CORRIGENDUM - 05 TO NIT NO-84687

Subject: Corrigendum-05 to Tender enquiry for Pre-Bid Tie up with the GIS OEM for Supply & Services of 220 kV GIS for IOCL's Panipat 220kV GIS S/stn Tender / Project.

Ref. No. **Technical Corrigendum-02**

Project: **Pre-Bid Tie up for,
EPCC 03 Package 220KV GIS AND ASSOCIATED WORKS for Maleic Anhydride Project at Panipat Refinery Petrochemical Complex of M/s. Indian Oil Corporation Limited.t**

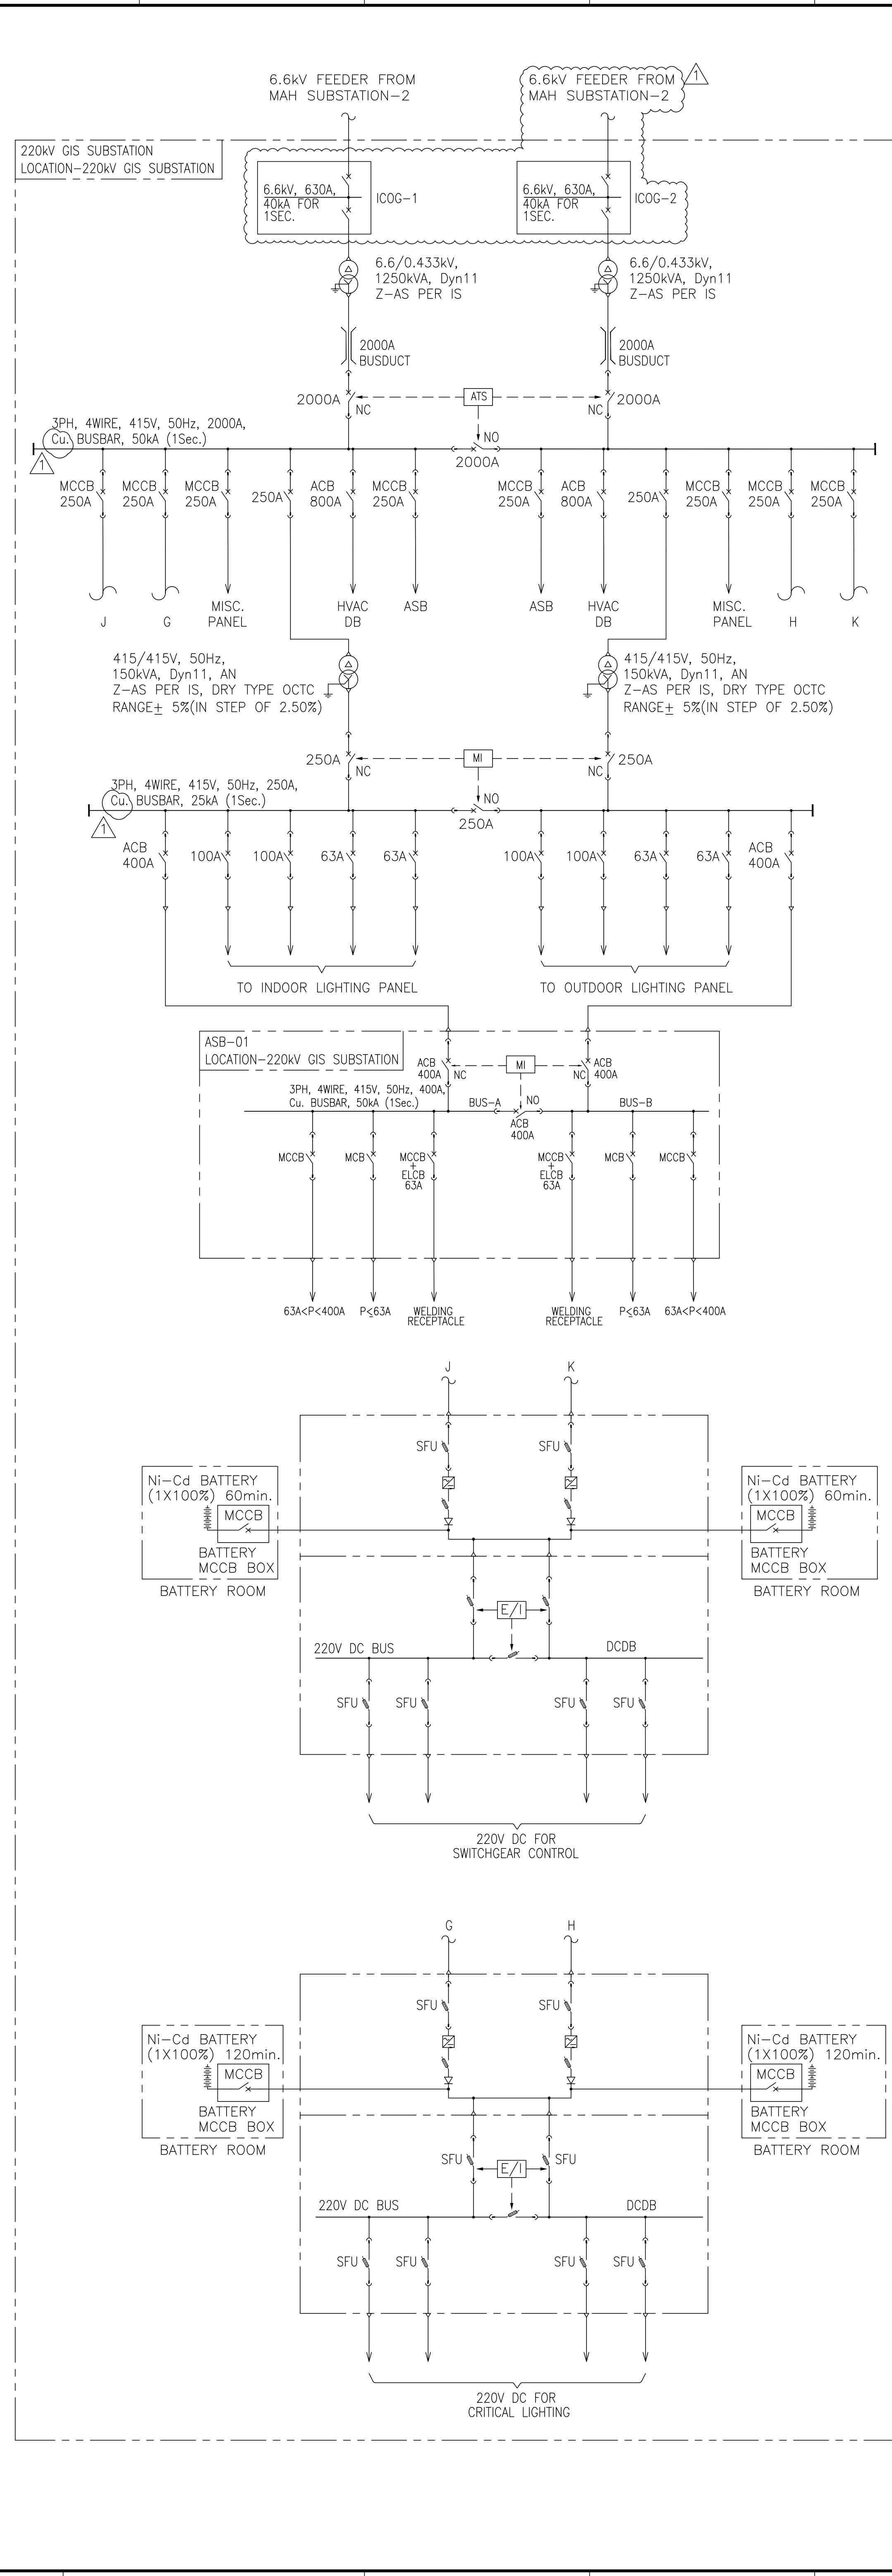
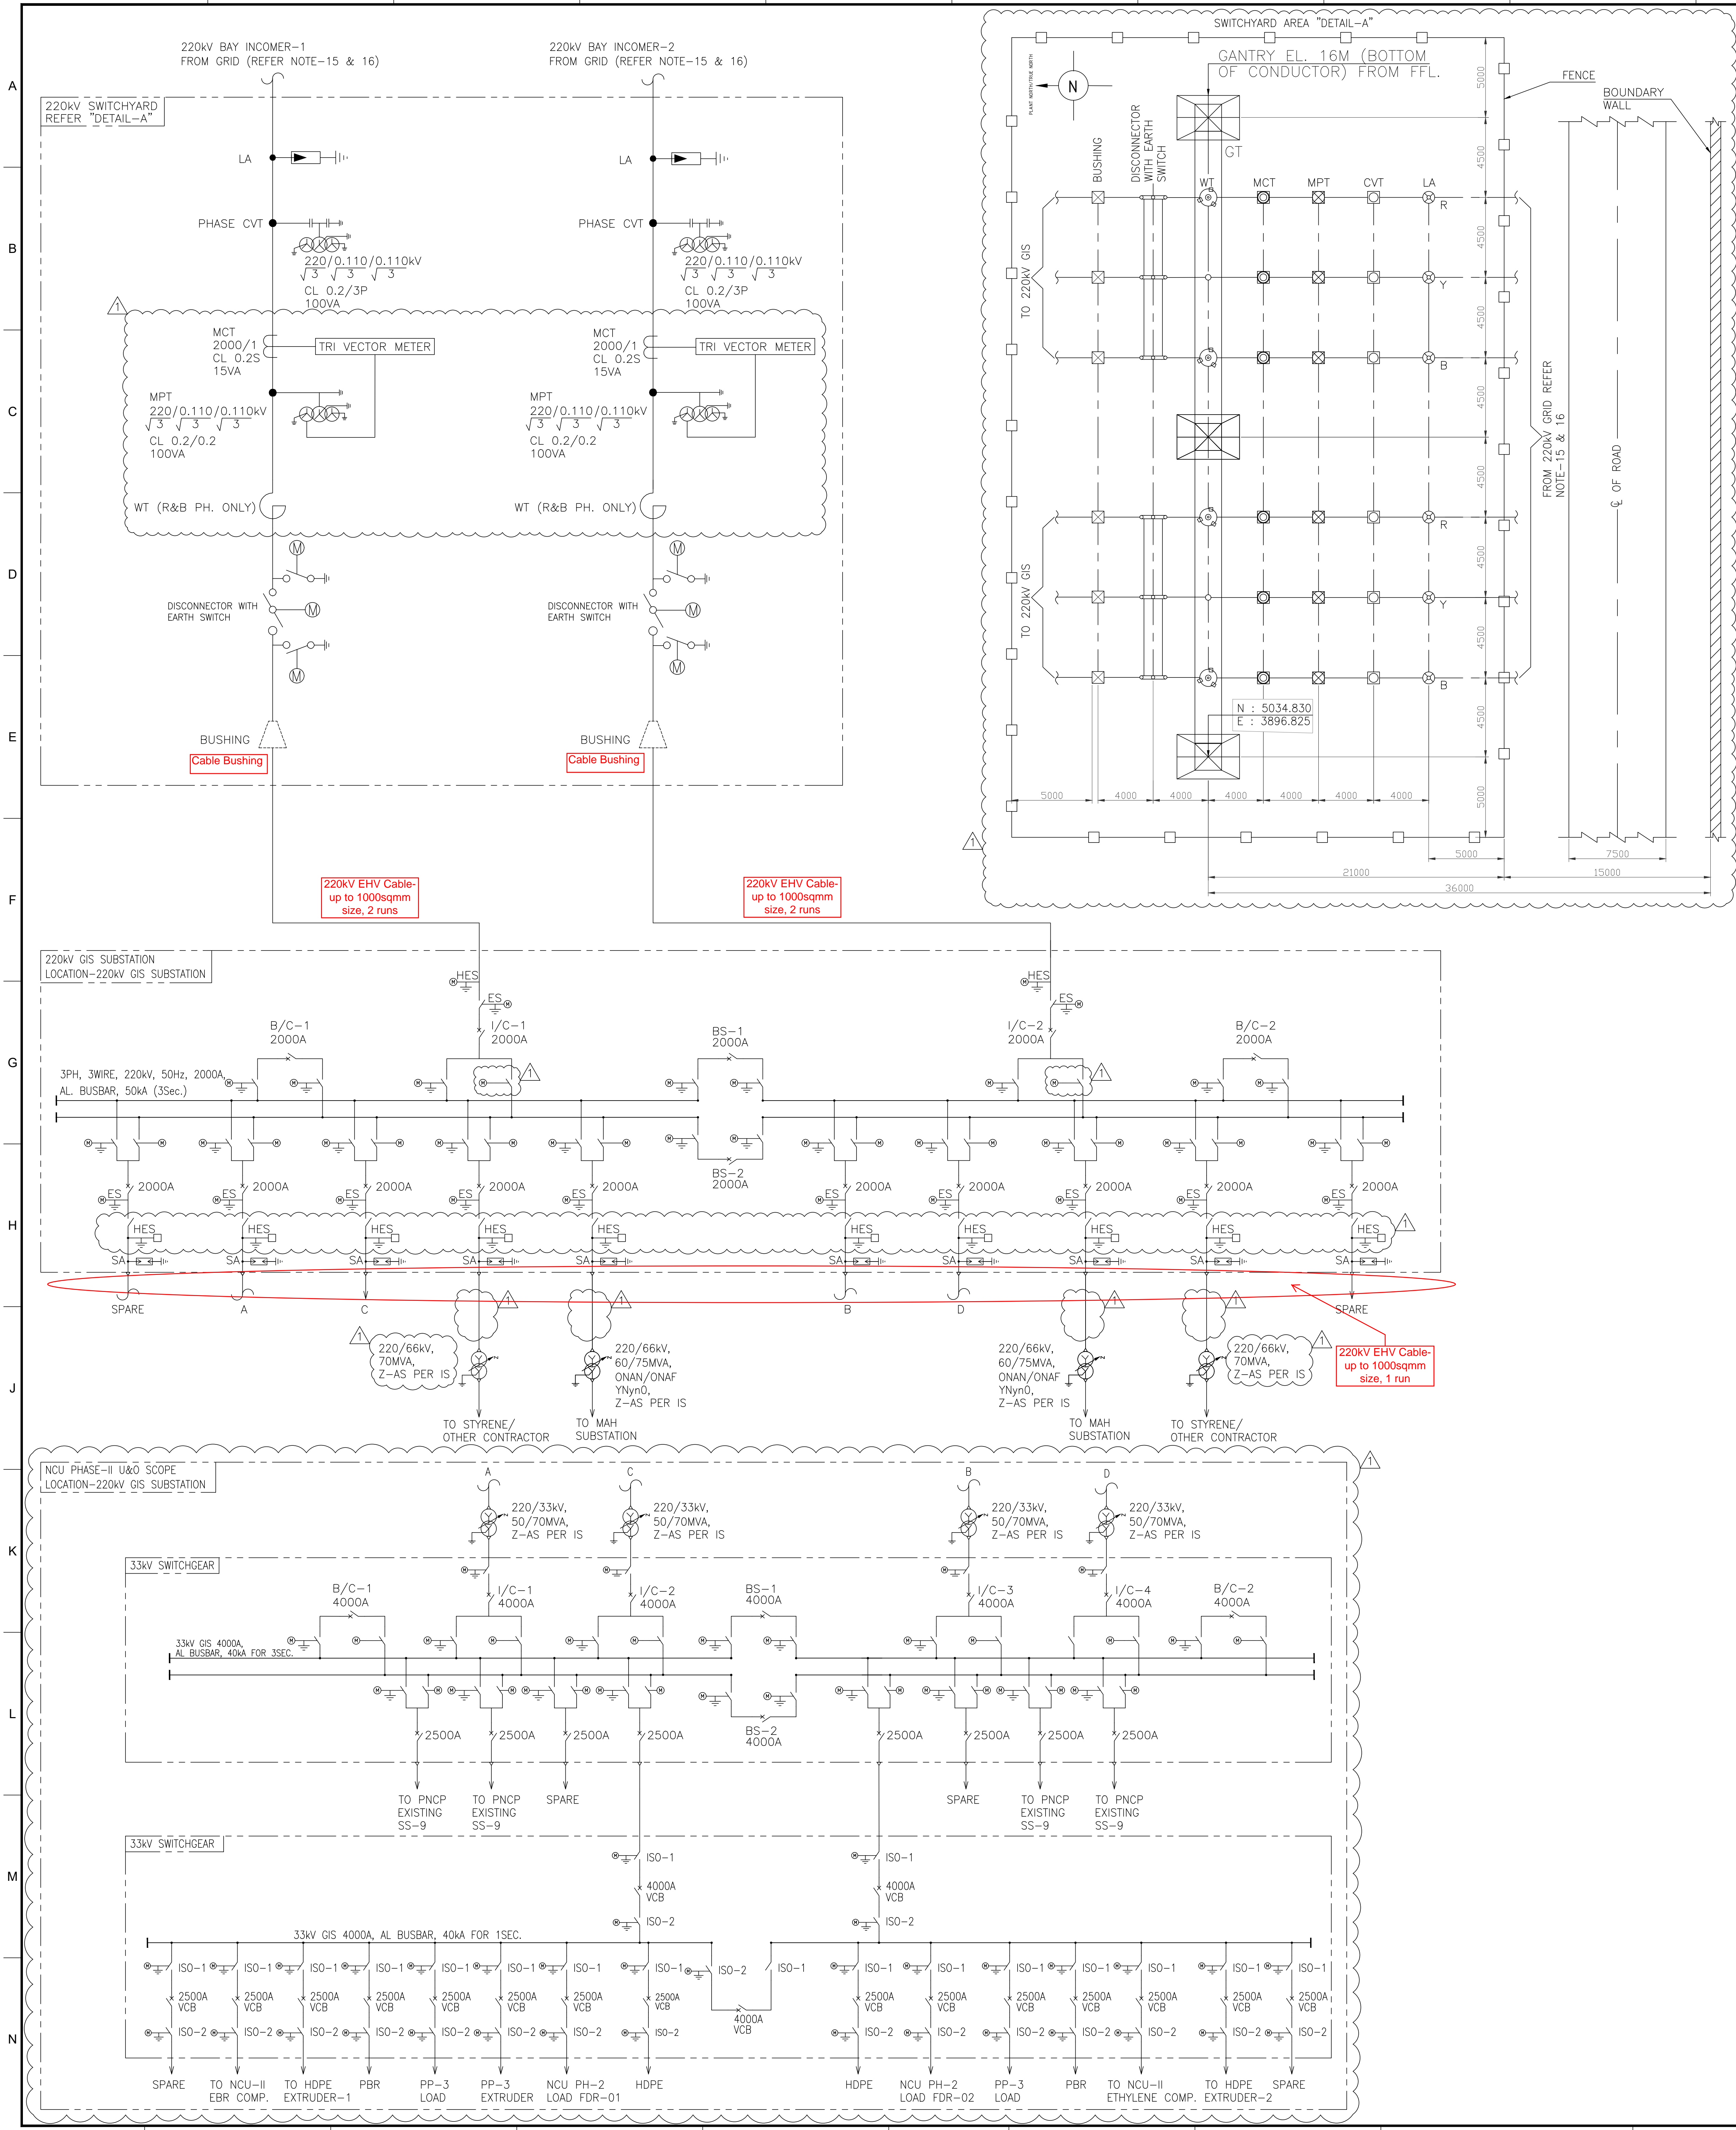
33.	Volume 2 / Section 5.4	359755-MDR-000-ICS-04A3-0002	-	-	PA System Block Diagram	-	<p>Addition:</p> <p>Refer to PA System Block Diagram</p> <p><u>Additional Information:</u></p> <p>EPCC-03 bidder shall note that complete PA system including exchange, Master Call Stations, Field Call Stations, beacons, speakers, acoustic hoods, etc. shall be supplied for the entire MAH project by EPCC-01 Contractor. This exchange shall be extension of existing PA system (Make: Industronic) located in Main Control Room (existing). Scope shall include modification of the existing system, processor, IO modules, cards, power supply system, etc. and panel size, colour shade, height shall be similar to the existing panels. The scope shall include providing power supply from existing source,</p>
